Opposition to Zoning By-Law Amendment
Files B10-26 and C14-26
Community of HOPEVILLE, ON

FORMAL OPPOSITION TO PROPOSED ZONING BY-LAW AMENDMENT AND CONSENT
112403 Grey Road 14, Hopeville – Part Lot 13, Concession 12
Township of Southgate

Figure 7: Impermeable surfaces in close proximity to existing residential properties

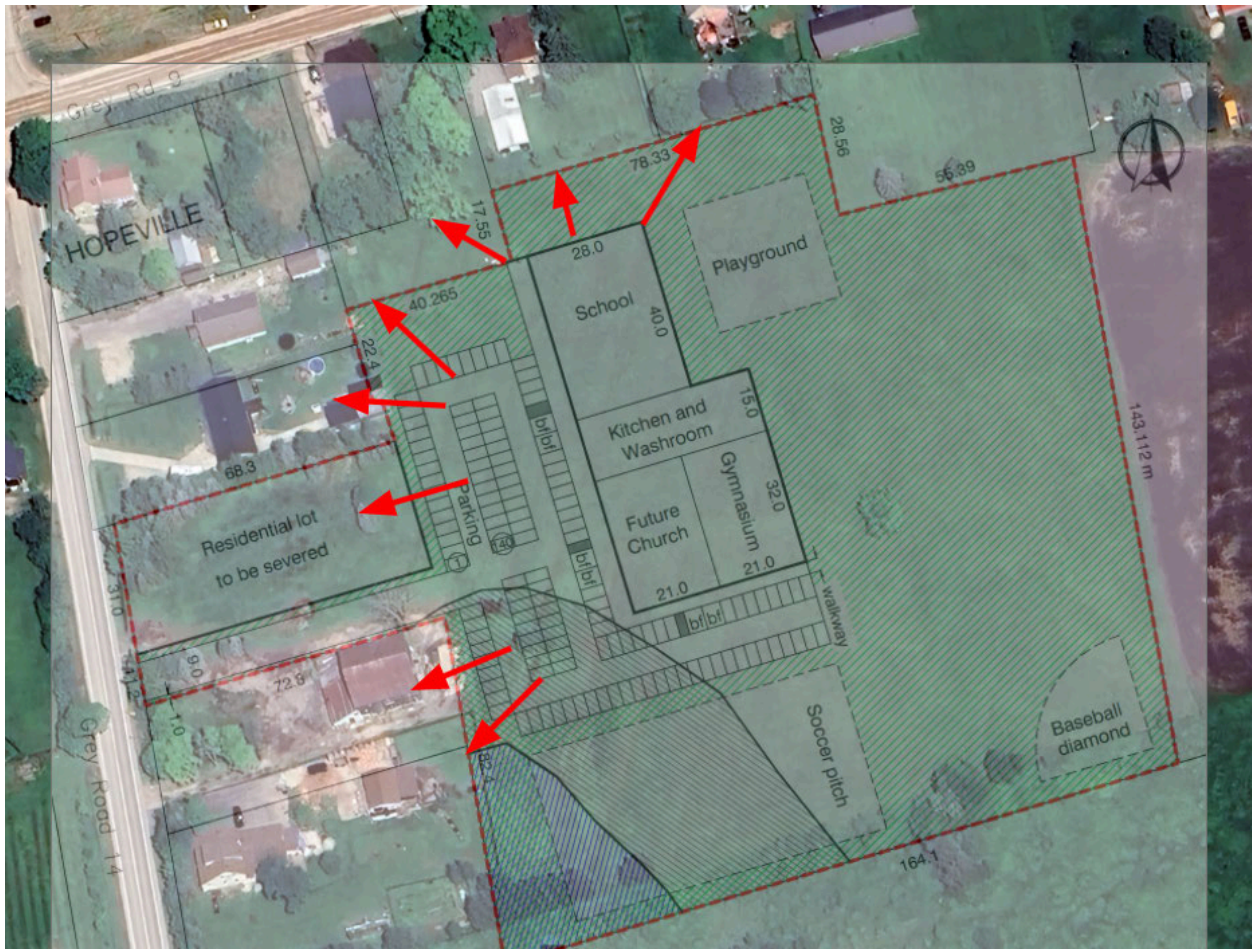
The Planning Justification Report acknowledges that the engineered site plan must address drainage and ensure that no new surface water flows are directed toward the County road, into the County stormwater management system or existing residential properties. It proposes that these matters be dealt with later through a Stormwater Management Brief and Site Plan process. We do not believe that potentially significant drainage matters should be treated as something that can simply be resolved after the zoning amendment has already been approved. Council should be satisfied that the proposed development can be appropriately designed and serviced before granting the zoning permission that enables the development.

Under the Ontario Planning Act post-development flow must be maintained or lessened when compared to pre-development flow. There is concern that almost 50% of pre-development permeable ground will be built over in close proximity to existing residential properties. This will not only limit options for directing water away from the new impermeable surfaces such as parking, walk ways and buildings but also have potential issues on the local water table. This implication puts neighbouring properties at risk of increased post-development flows without proper engineering studies to justify the position of the parking surfaces and buildings regardless of limitations caused by By-Law Zoning setbacks for those particular features.

Potential drainage issues from parking lot runoff, snow clearing, snow melt and other construction features can directly impact multiple existing properties if not determined prior to approval of the zoning amendment.
